**RE: New Office Warehouse for Purvis Industries (E17D041F)
Singer Blvd. & Midway Park Blvd.
Conceptual Grading and Drainage Plan
Engineer Stamp Date: 10-30-15**

Re: New Office Warehouse for Purvis Industries
Singer Blvd. & Midway Park Blvd.
Grading and Drainage Plan

Based on the comments made regarding the drawings submitted 9/2/15, the following addresses those comments:

ENGINEER'S SEAL	DRAINAGE	OMMISSION No. 15-121
	JOB # 019-15-200	DATE 10-2015 REV 10-2015
HUGH W. FLOYD P.E. 16633	FLOYD DEVELOPMENT SERVICES, LLC DEVELOPMENT, ENGINEERING, & WATERSHED CONSULTING 918 PINEHURST RD SE, SUITE 101 RIO RANCHO, NM 87124 HUGH@DEVELOPNM.COM 505-366-4187	SHEET: C-1 1 OF 4

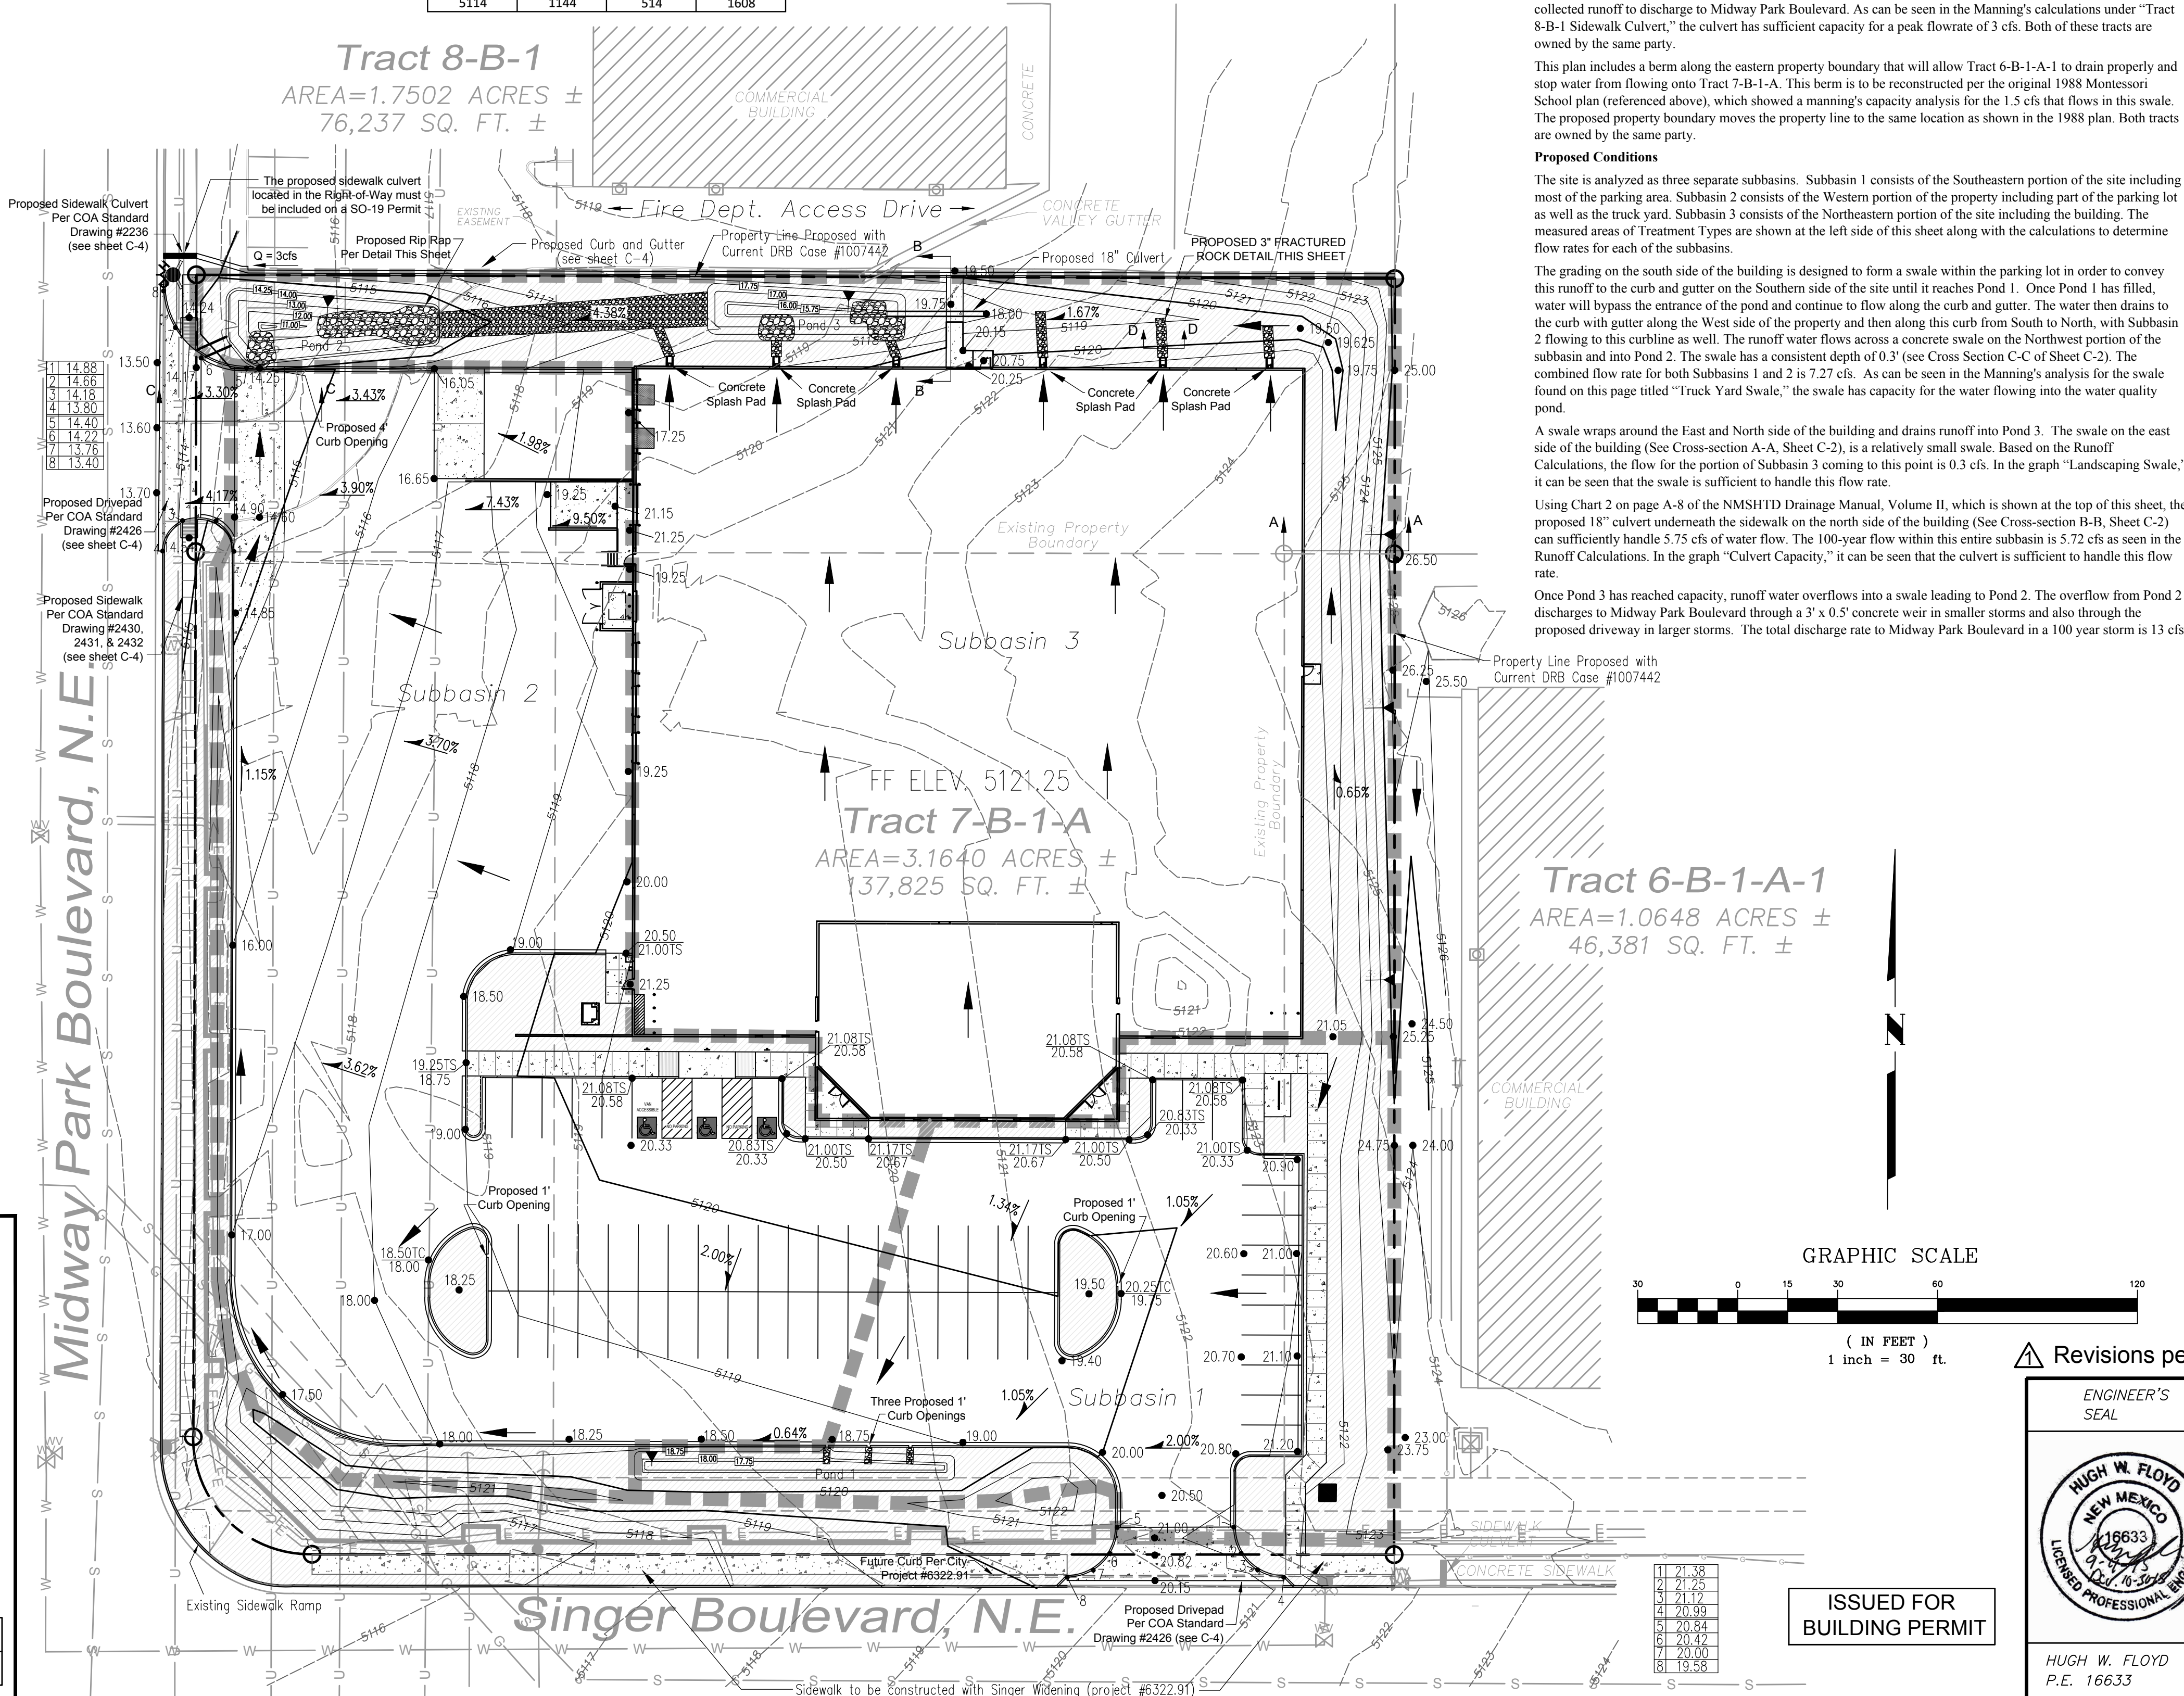
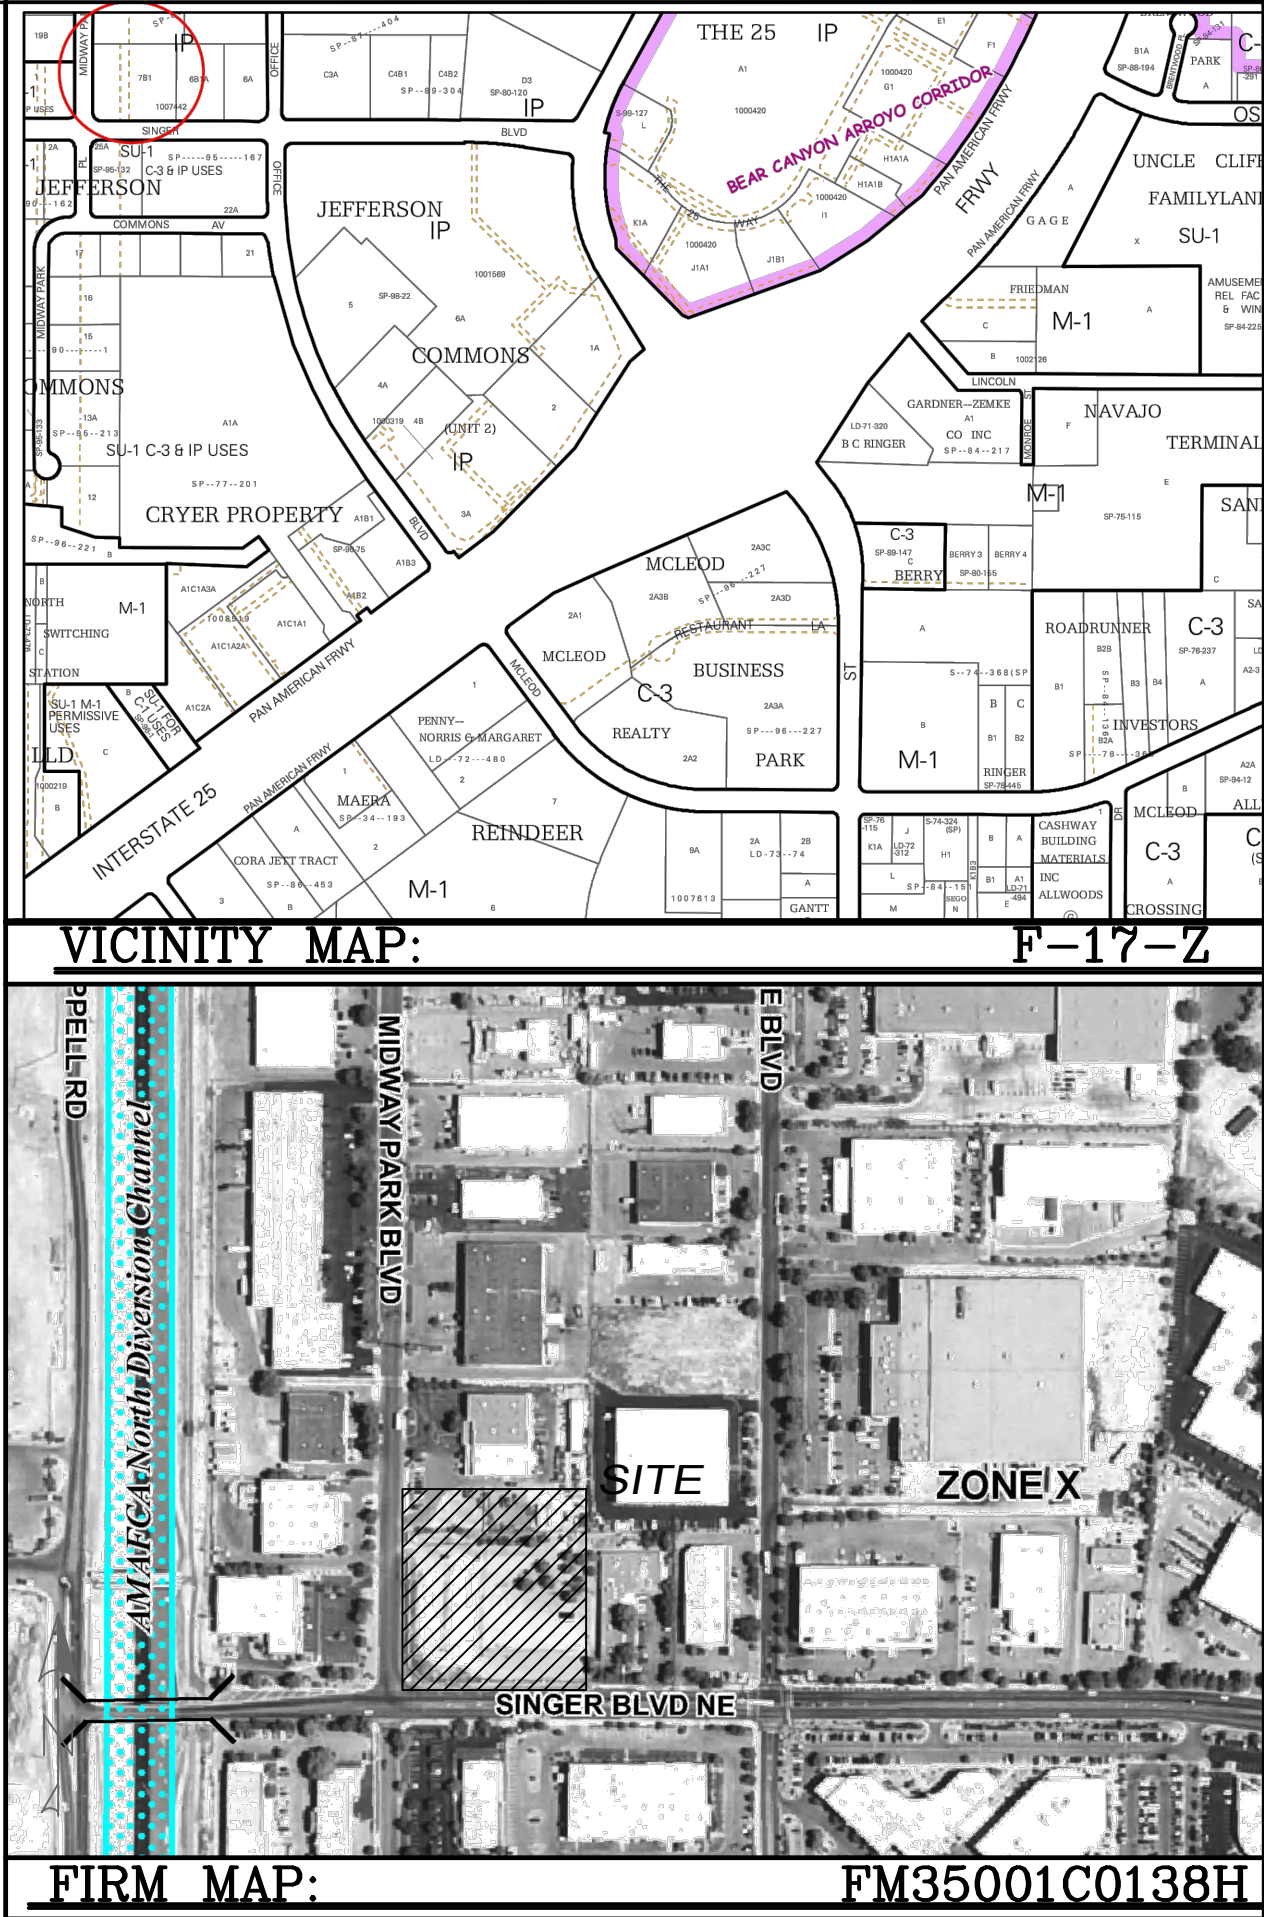
1. In the narrative, indicate the Drainage File number of all reports that are used to research this site, ie. Singer Business Park DMP is E17D041F; Montessori School is also E17D041F
See updated narrative on Drainage Sheet (C-1)

2. The Singer Business Park Drainage Plan (1984) is missing basin maps but the narrative explains the drainage scheme and this information should be summarized in the narrative. Indicate how basin 1-B and 2-B were intended to drain, and how flows ultimately discharged to Midway and then to a channel. Also state the developed discharge from this site, as the downstream channel would have been sized based on this amount.
See updated narrative on Drainage Sheet (C-1)

5. Provide information or excerpts from the lots to the east (F17D058 and F17D054) to determine how the drainage of these lots will be directed south through the new swale. The last paragraph of the narrative should be labeled “OFFSITE FLOWS” and be presented before “Proposed Conditions” in the narrative. Since existing off site flows to the east are intended to flow south to the existing SW culvert, show that the swale and existing SW culvert have sufficient capacity.
See updated narrative on Drainage Sheet (C-1)

7. Provide calculations to determine the amount of First flush that must be retained for each sub-basin.
See updated sheets (Drainage, left side under “Water Quality First Flush Volumes Required”)

9. Pond Volume calculations need only be to 2 significant digits.
See updated Drainage Sheet
10. How will the “first flush” from sub-basin 1 enter Pond 1? Show openings intended to direct flows to both Pond 1 and 2.
See updated sheets

17. Provide a FIRMette or a description of the flood zone and what map the info came from.

See updated Drainage Sheet (C-1)

SHEET: C-2
2 OF 4

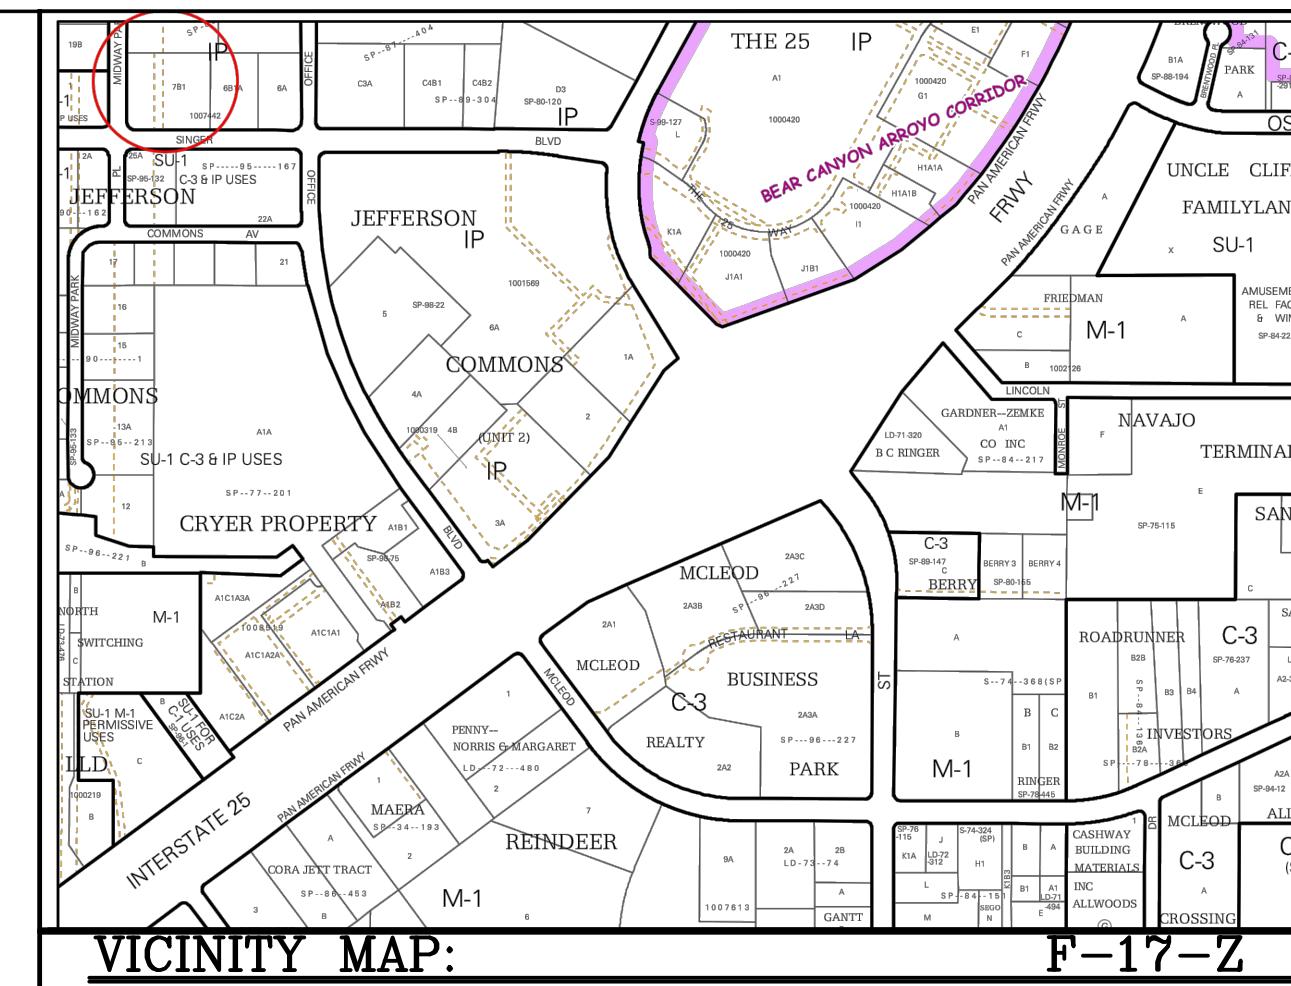
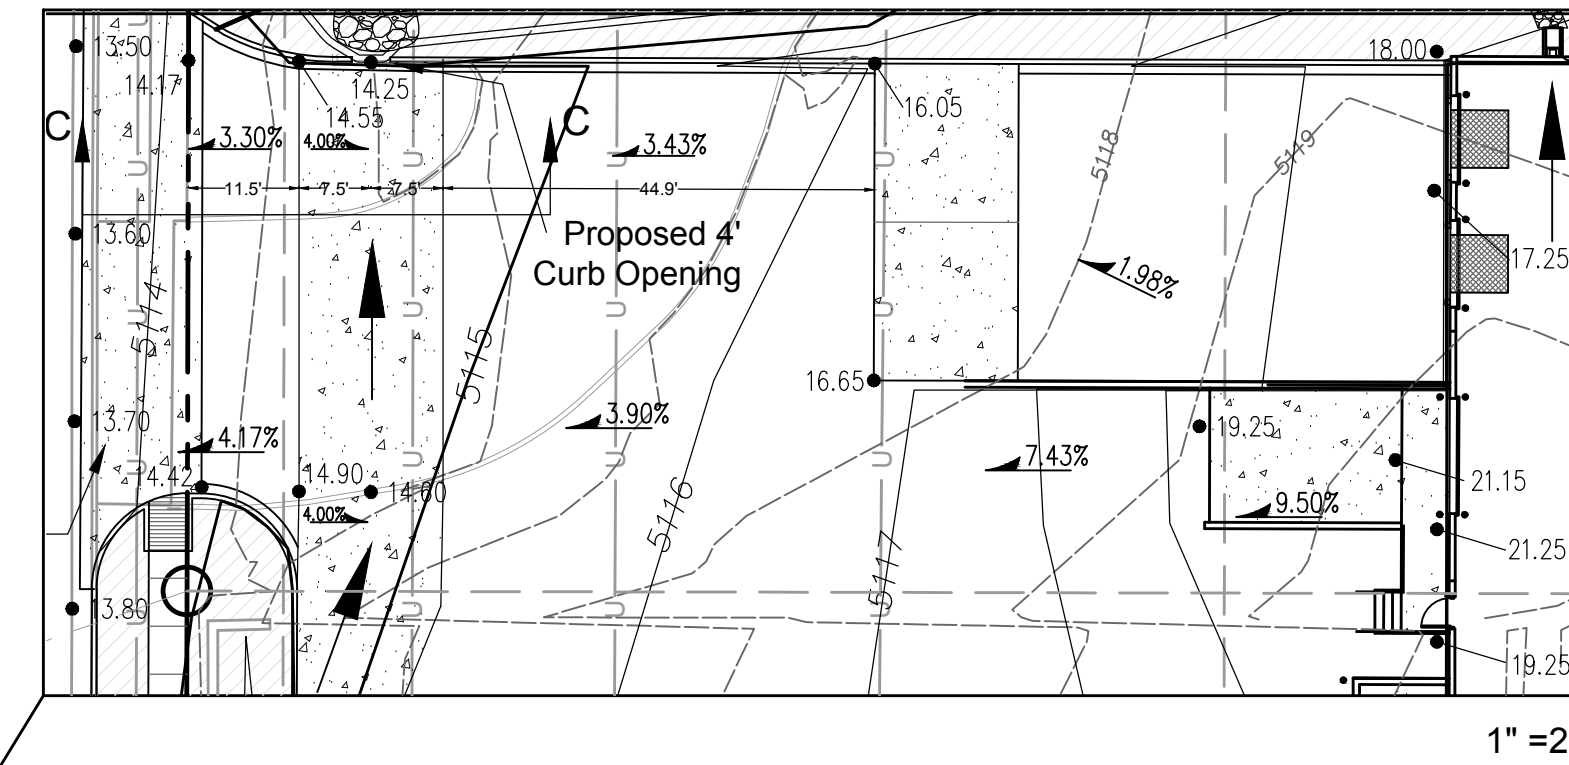
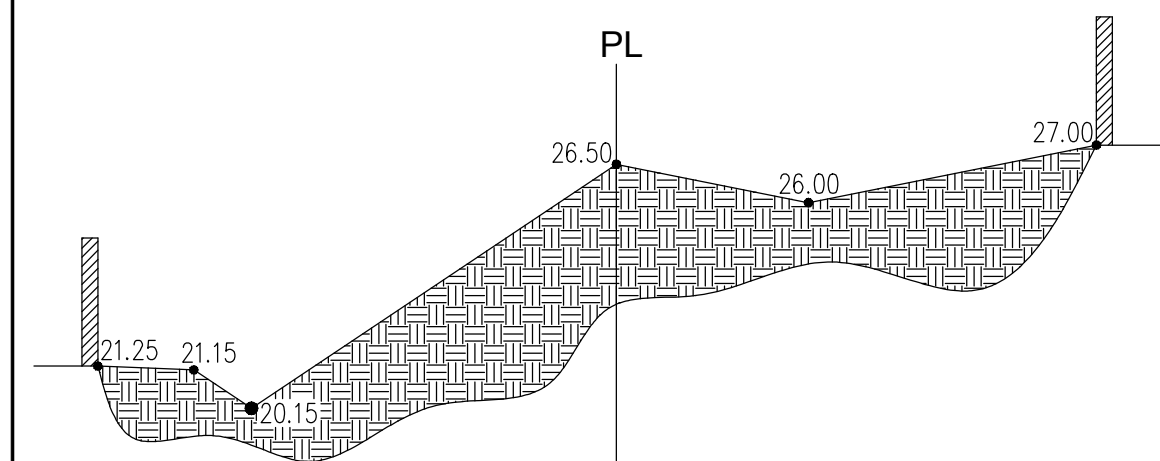
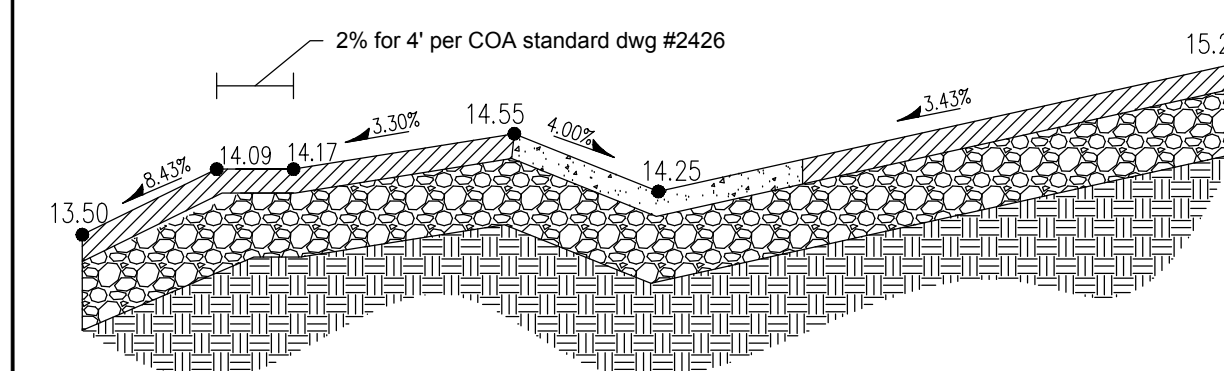
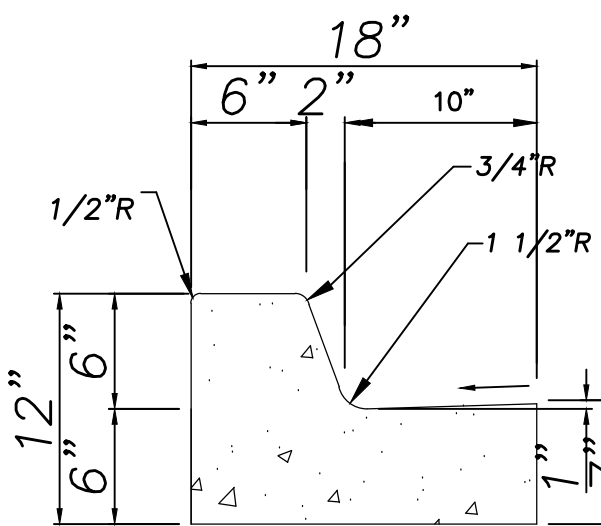
4. An exhibit showing existing and proposed lot lines would be helpful. Also show existing building, and indicate those intended to be demolished.
See updated Grading Sheet (C-2)

6. How much flow will be directed from the existing valley gutter to the north (Lot 8B) to the proposed SW Culvert? Show capacity calculations for the SW culvert.
See updated sheets

11. Show rip-rap or concrete pads below roof drains, and show how discharge will either be directed to Pond 3 or the swale on the east side of the pond.
See updated sheets

12. Call out the 18” pipe culvert on the plan view. Is there sufficient cover for this culvert?
See updated sheets. Yes, there is sufficient cover between the top of the culvert and the bottom of the concrete sidewalk. This area will only see foot traffic and no vehicle loads.

13. Show erosion protection between Pond 2 and 3.
See updated sheets

18. Provide a benchmark

19. Provide build notes/details for the 3' x 0.5' concrete weir and Pond 2.

See updated Grading Sheet (C-2)

See updated Grading Sheet (C-2)
